STERLING RANCH FILING 2-MARKSHEFFEL ROAD BETWEEN VOLLMER ROAD - STERLING RANCH ROAD

STREET IMPROVEMENT PLANS

FEBRUARY 2018

"ULTIMATE"
MARKSHEFFEL ROAD

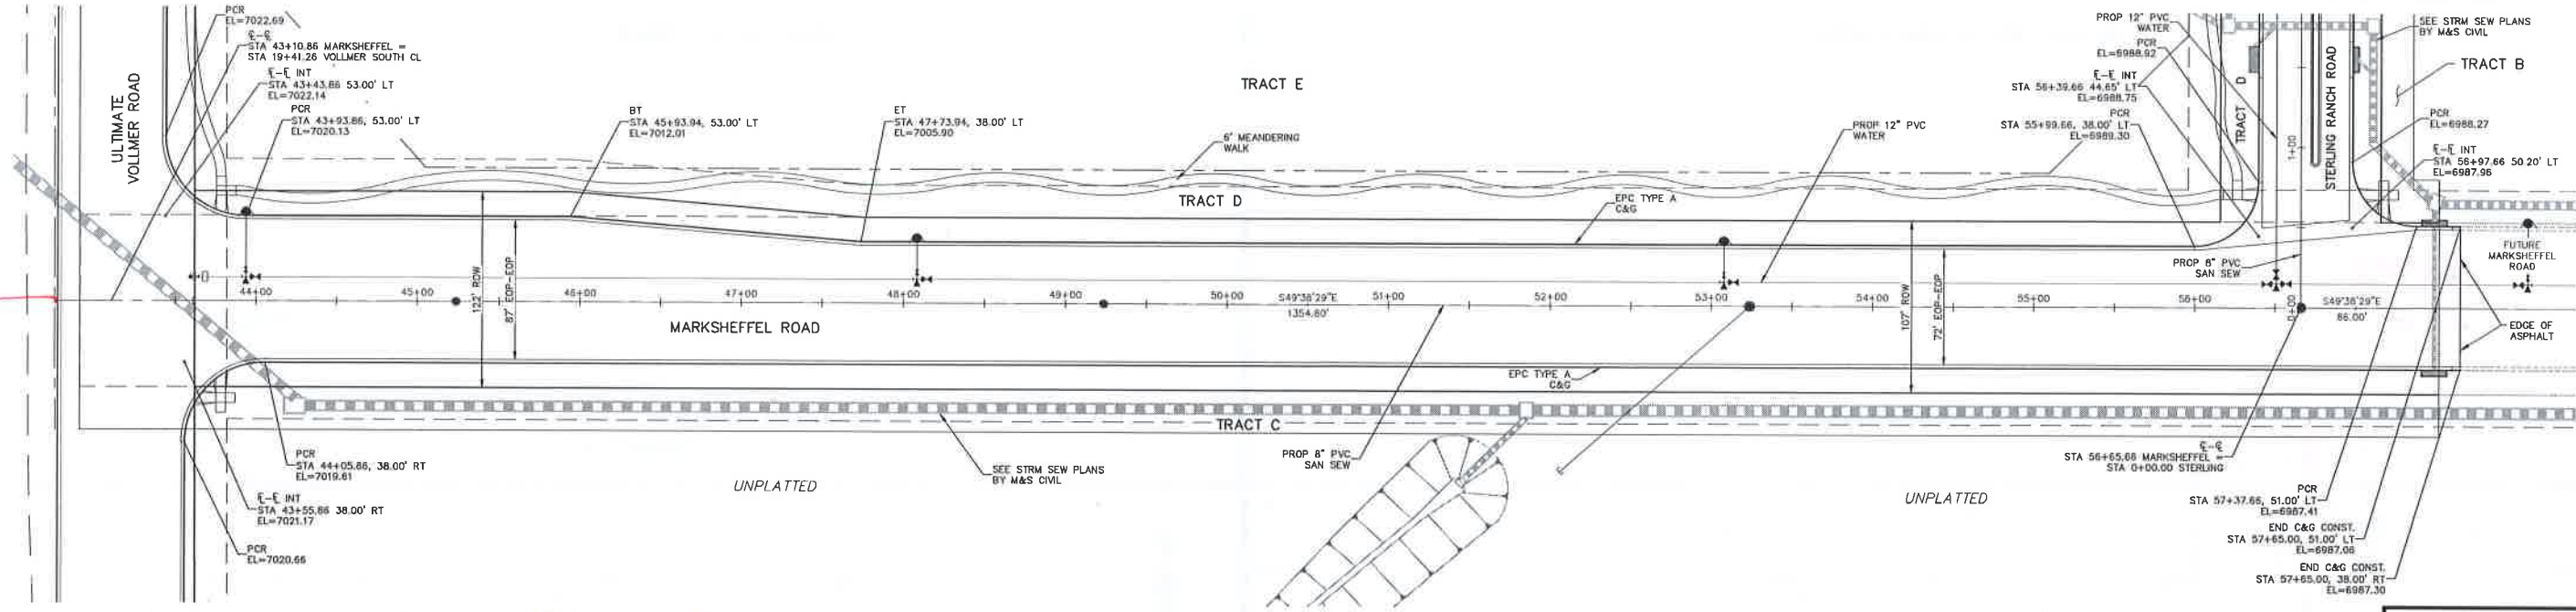
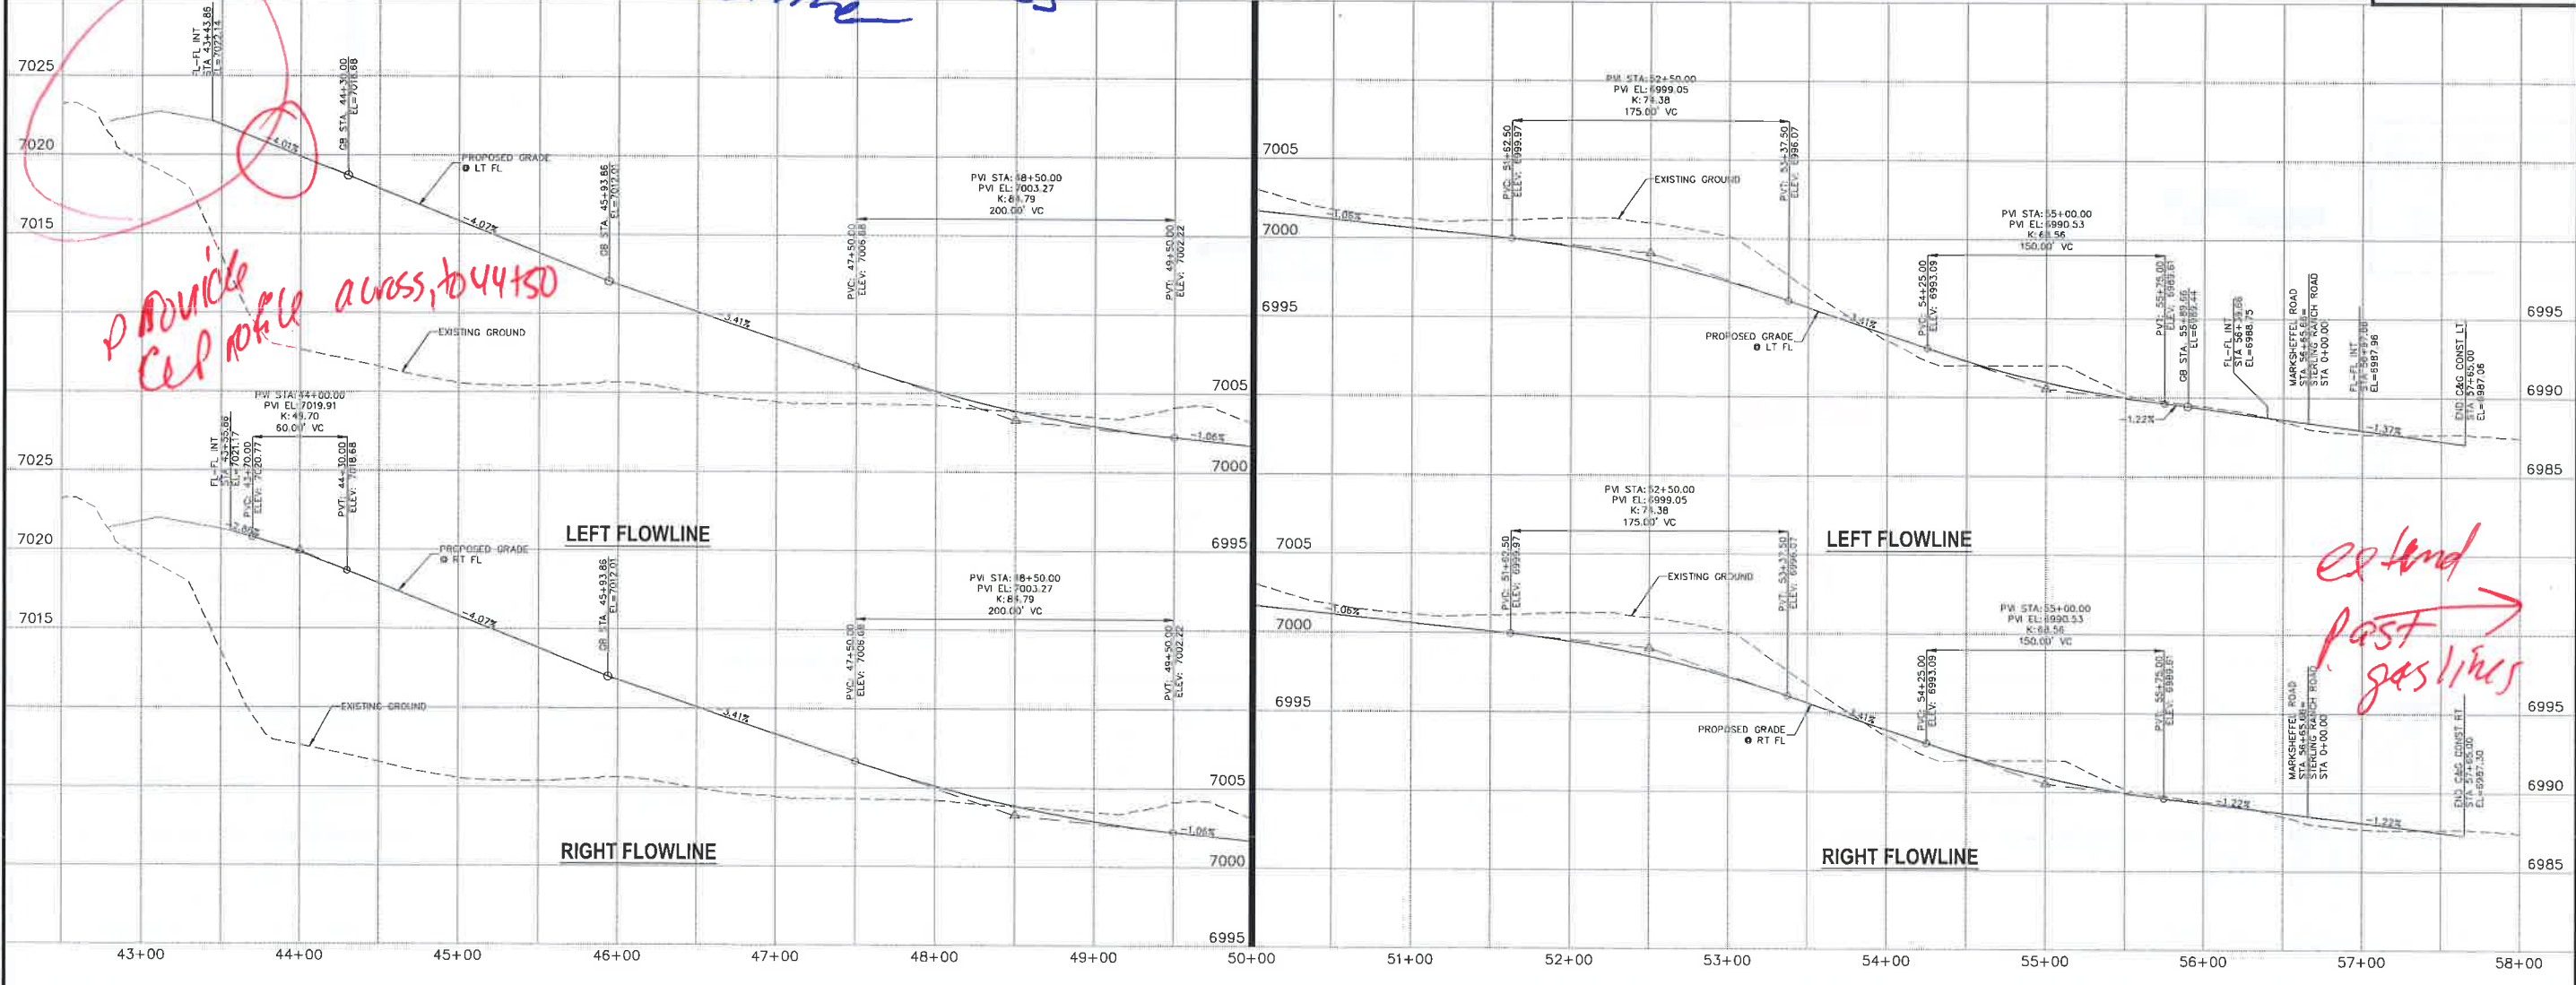
K-Va loc provide profile across Vollmer

provide C&G profile across to 44+50

extend past gas lines

STERLING RANCH - MARKSHEFFEL ROAD
 SIGNAGE & STRIPING PLAN
 PROJECT NO: 09-002
 DATE: 2/26/2018
 SCALE: HORIZONTAL: 1"=50' VERTICAL: N/A
 DESIGNED BY: DM
 DRAWN BY: JMP
 CHECKED BY: VAS
 SHEET 6 OF 6
 S106

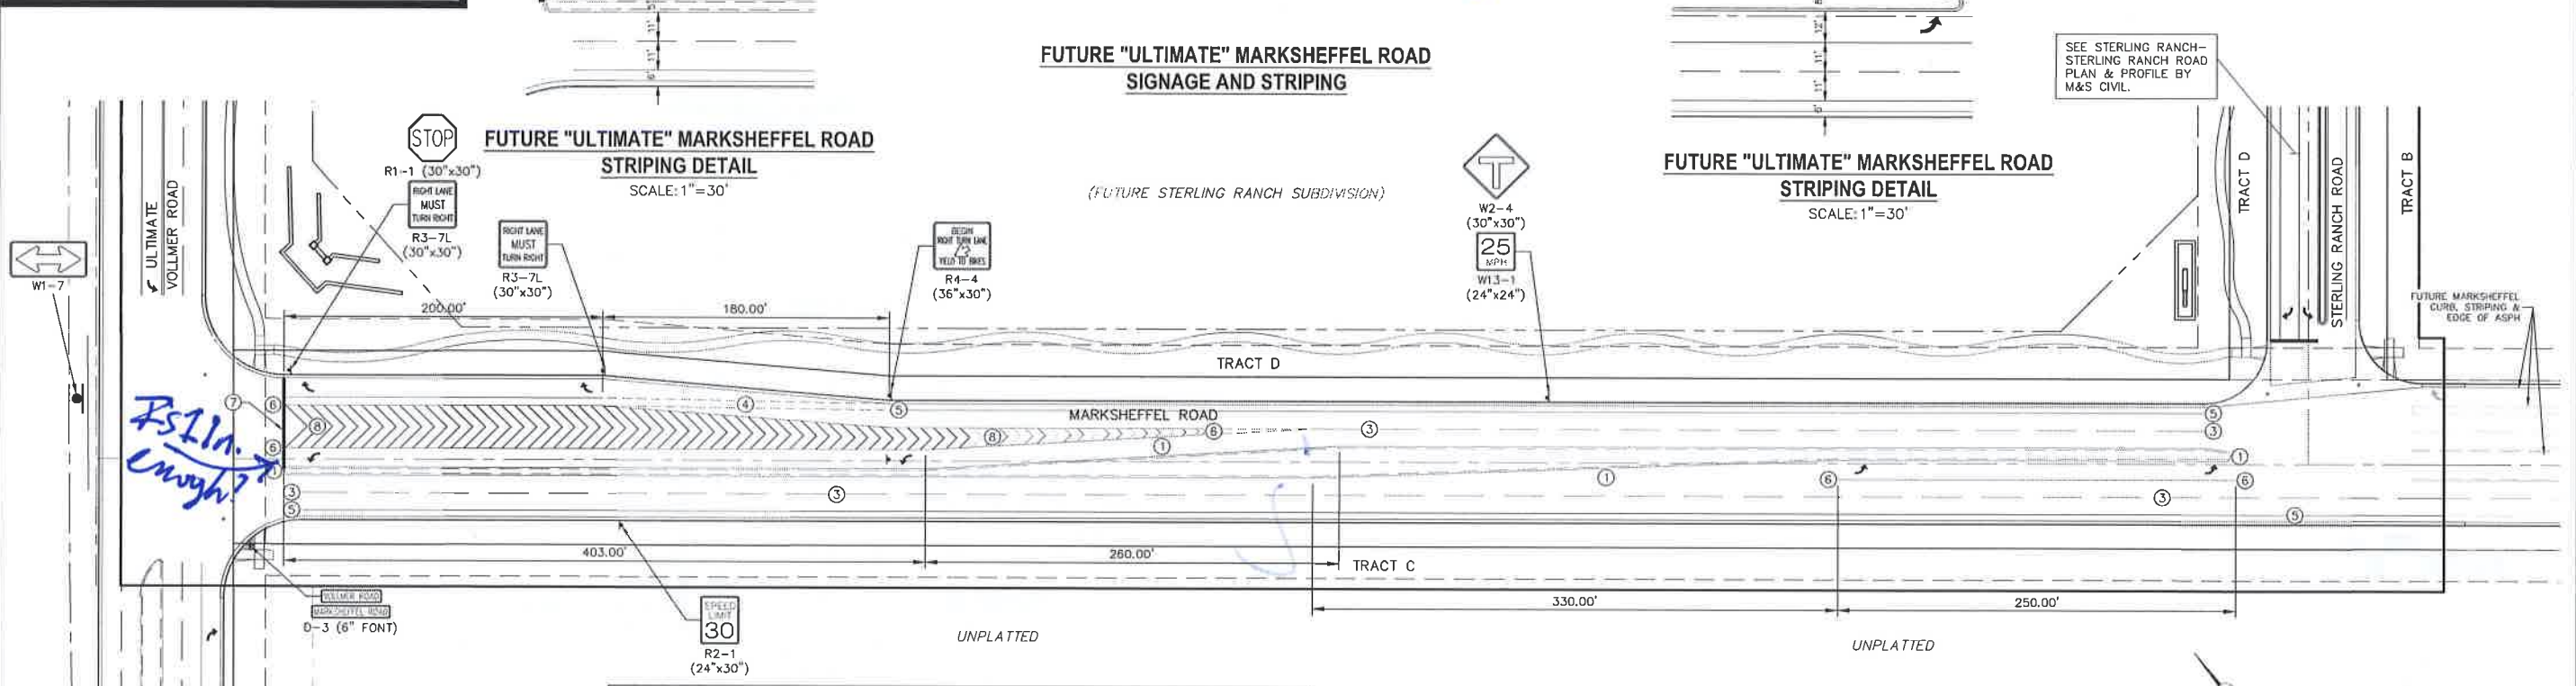
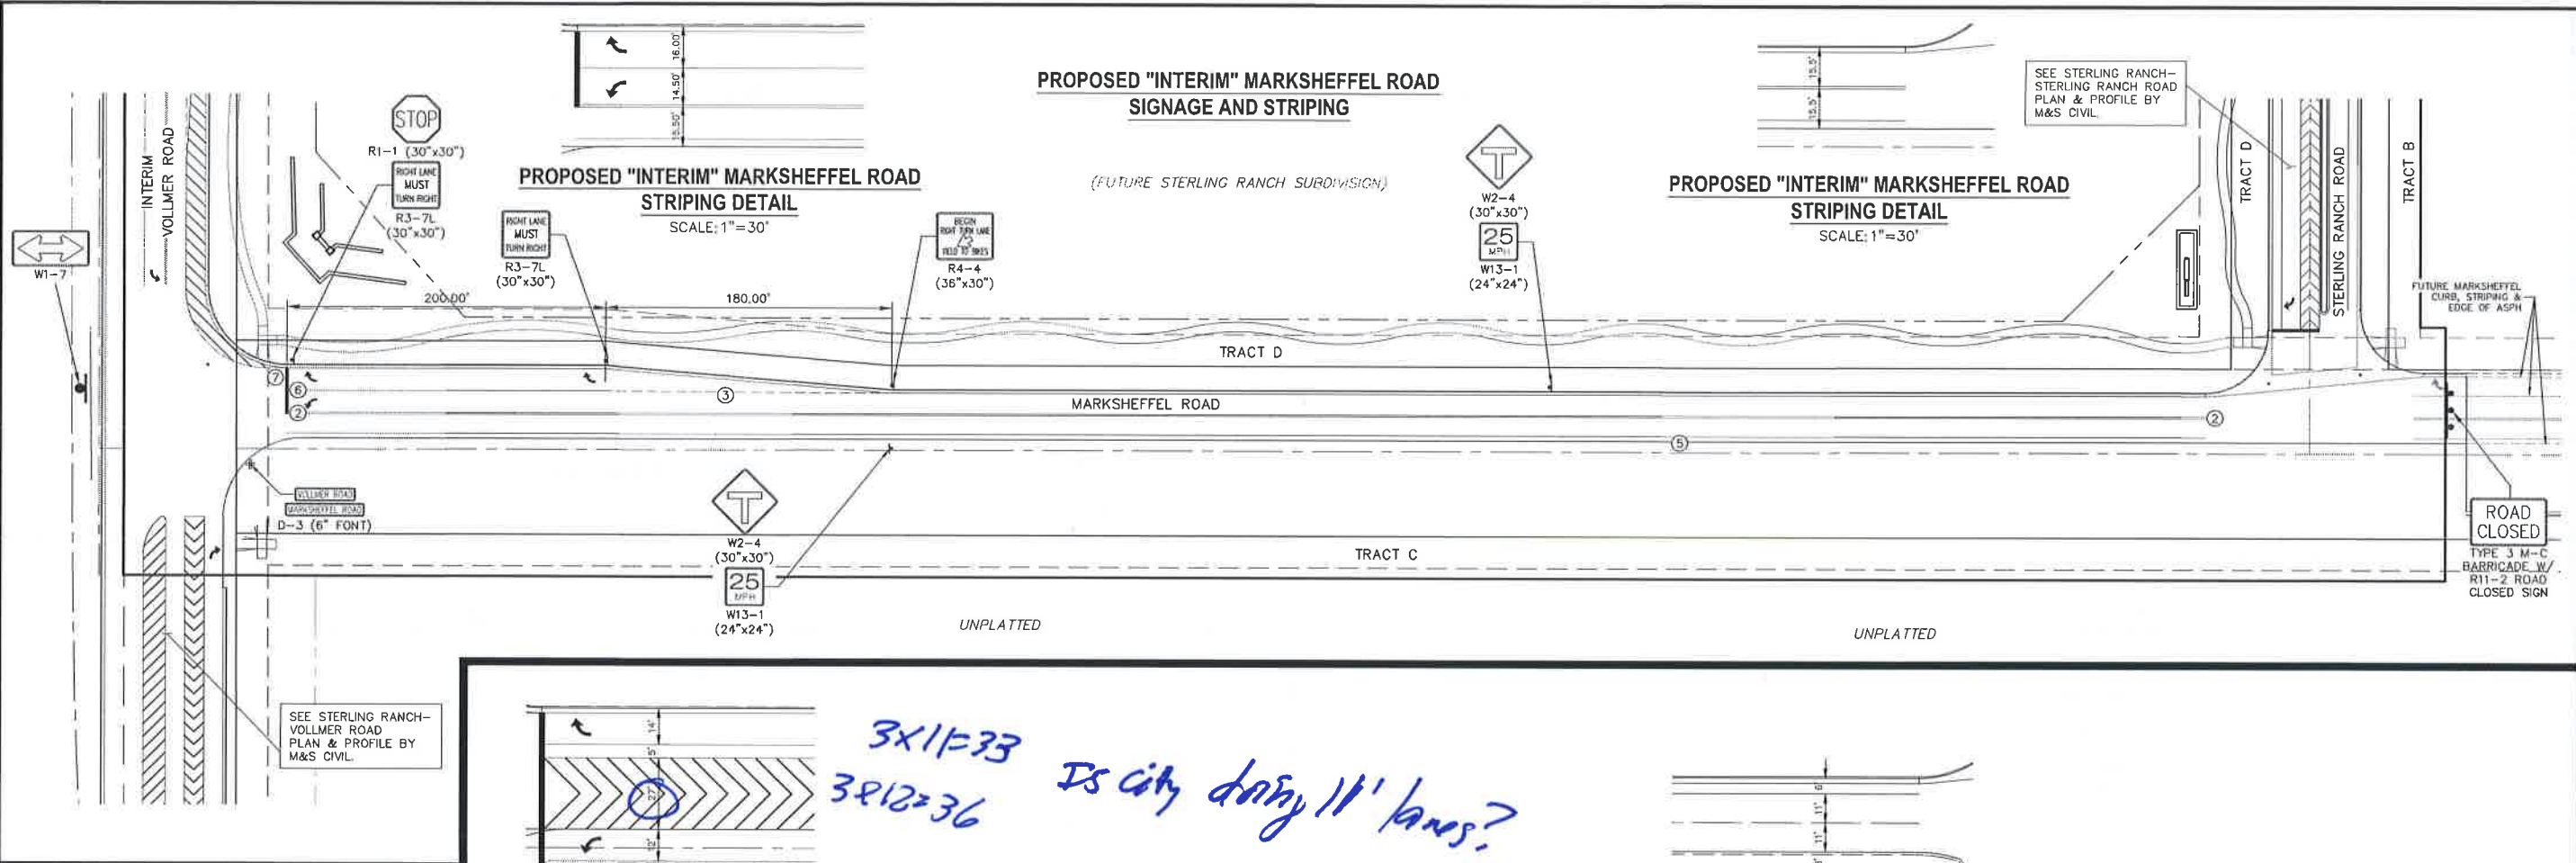
Handwritten notes:
 3x15=37
 2x15=30
 22' 2" 11' 11" 11' 11" 11' 11"
